Staff Report

File #: 24-183

City Council review of an appeal filed by a neighboring property owner following the Planning Administrator's decision approving a 405-unit multi-family residential development, Urban Growth Area Preliminary Declaration, Class 3 Site Plan Review, Class 1 and Class 2 Adjustments, Class 2 Driveway Approach Permit, Class 1 Design Review, and Property Line Adjustment Case No. UGA-SPR-ADJ-DAP-DR-PLA24-03 for property located at 4650 Hazelgreen Road NE.

**URBAN GROWTH PRELIMINARY DECLARATION / CLASS 3 SITE PLAN
REVIEW / CLASS 2 ADJUSTMENT / CLASS 1 ADJUSTMENT / CLASS 2
DRIVEWAY APPROACH PERMIT / CLASS 1 DESIGN REVIEW / PROPERTY
LINE ADJUSTMENT CASE NO.: UGA-SPR-ADJ-DAP-DR-PLA24-03**

**PRELIMINARY SITE PLAN - NORTH
NORTHPLACE APARTMENTS PHASE 2
I&E CONSTRUCTION, INC.
SALEM, OREGON**

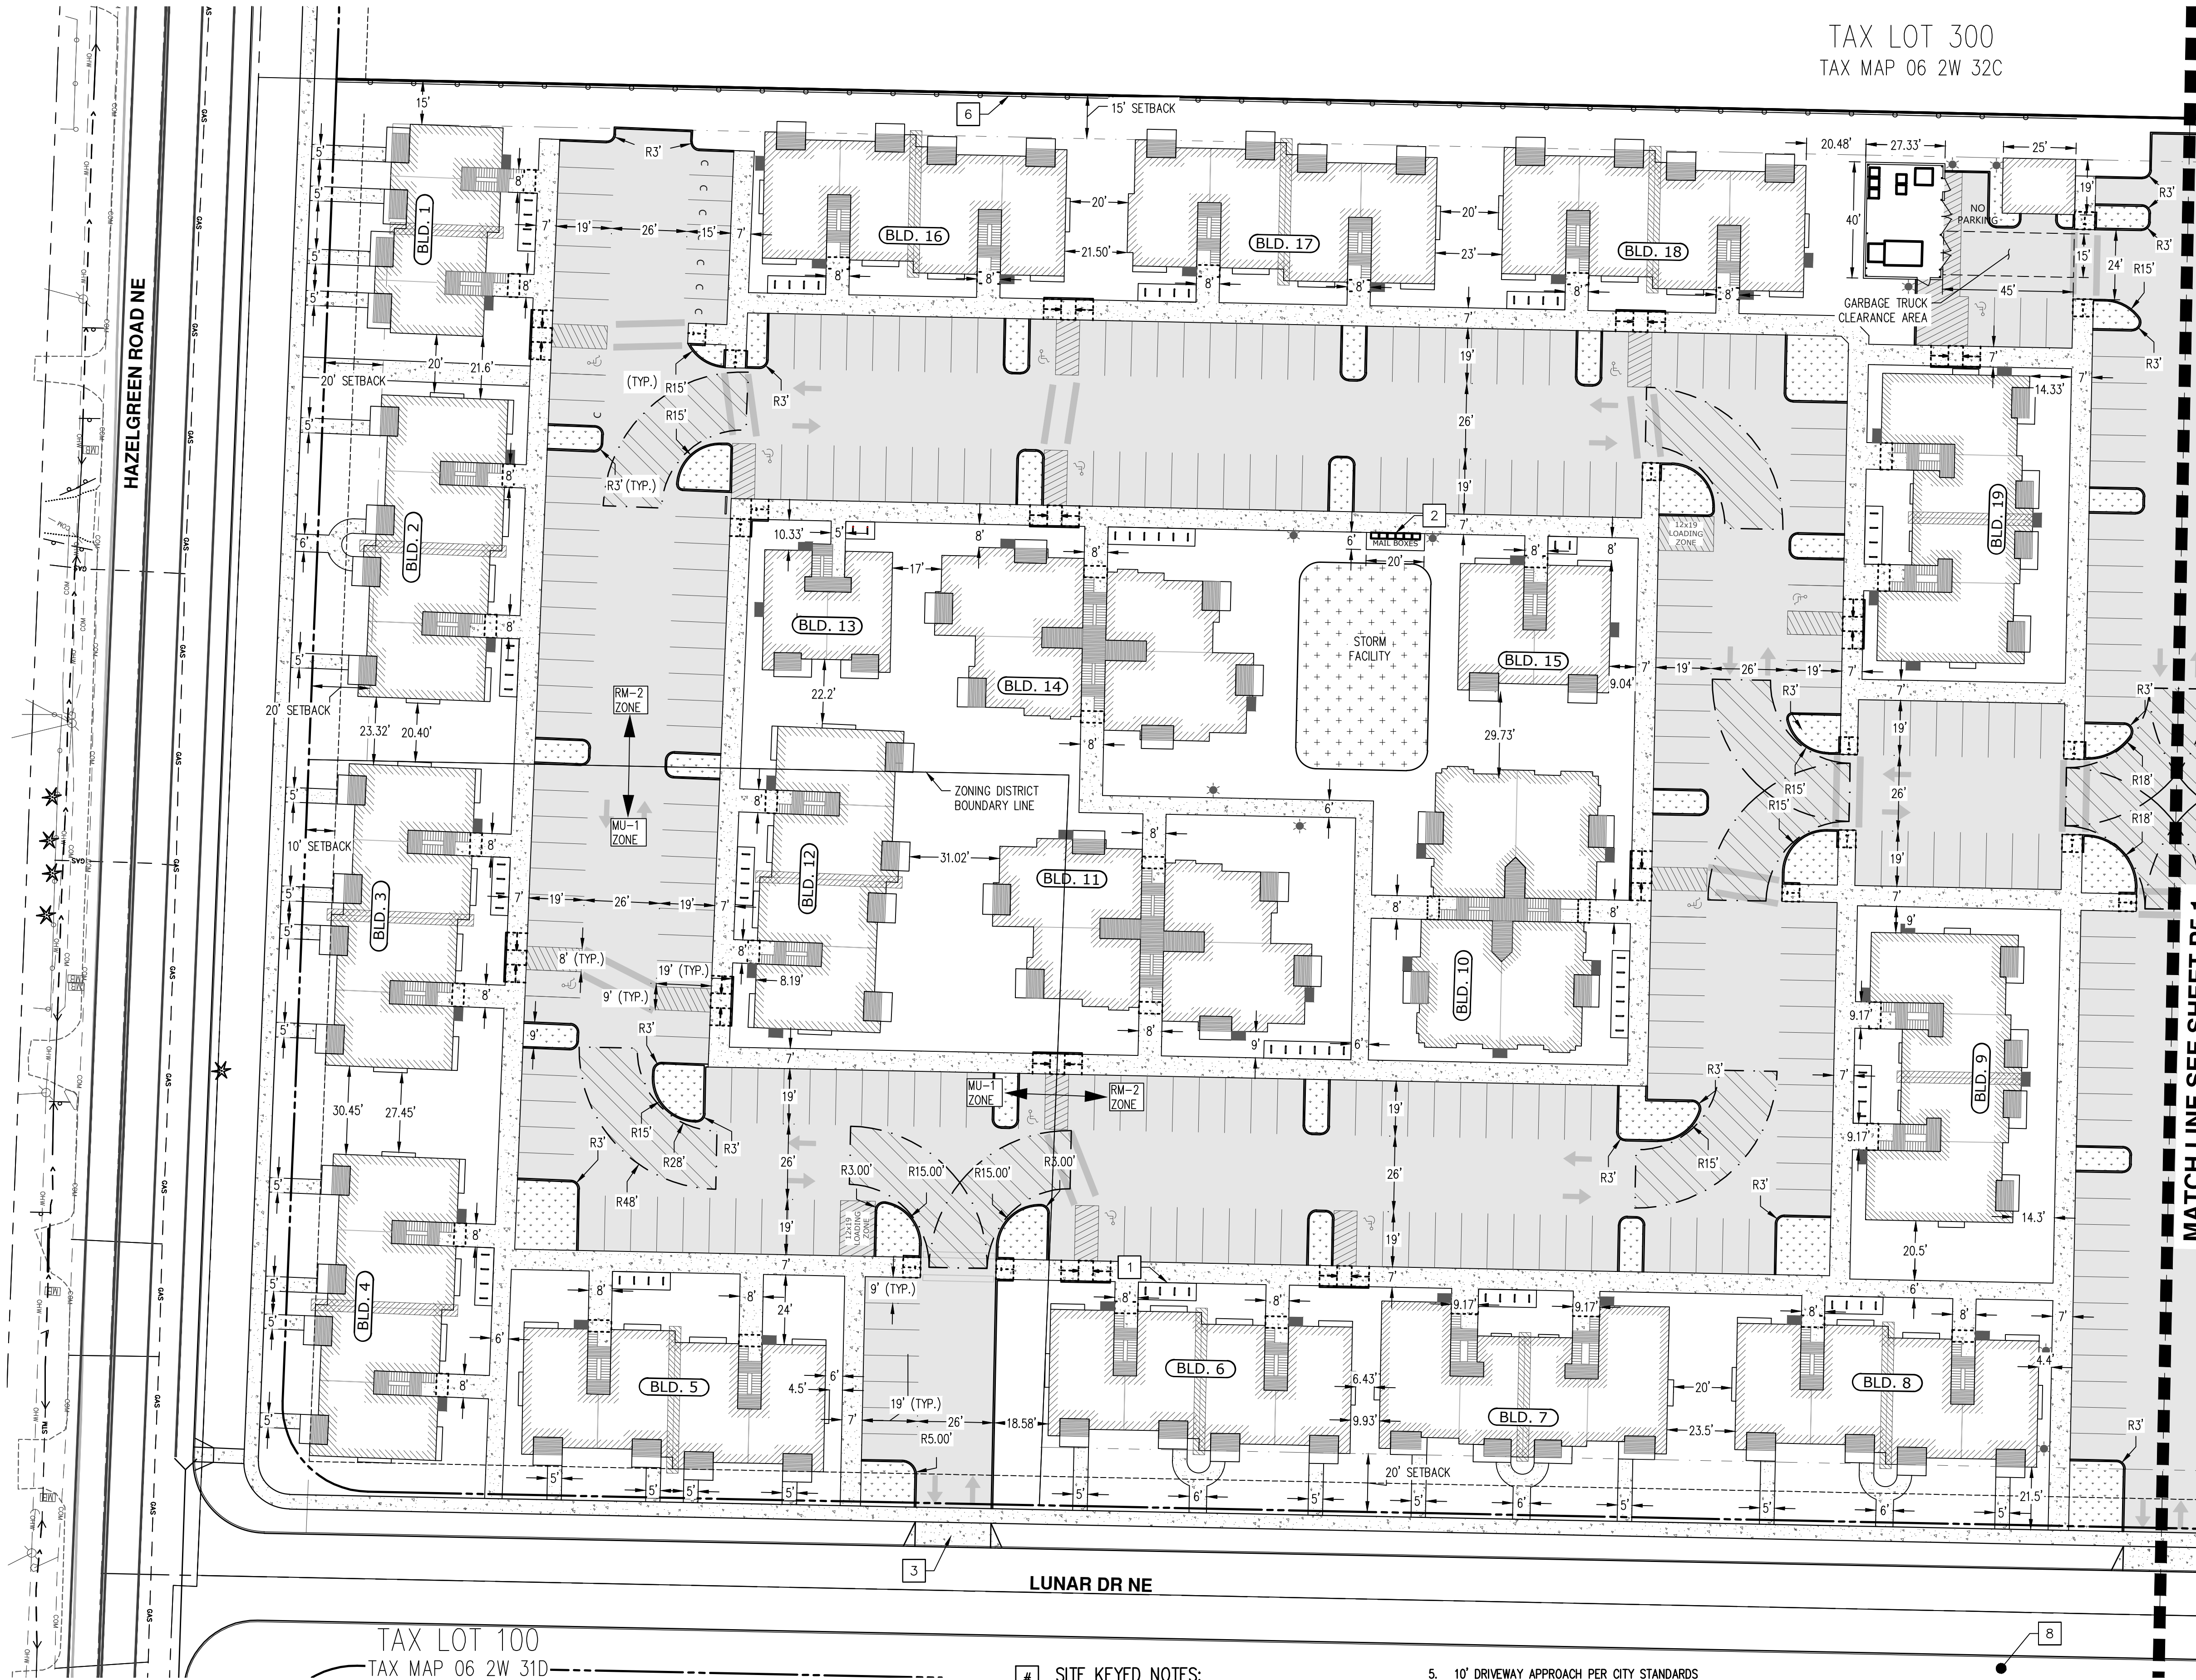
- 1) Hydrant and FDC shall not obstruct Fire Department access with hose lay. See sheet P7.0 near buildings 5 and 6.
- 2) Buildings that exceed 30 feet in height per the Oregon Fire Code require aerial access, 30-foot minimum. Appendix D105.3 as amended in SRC Chapter 58.
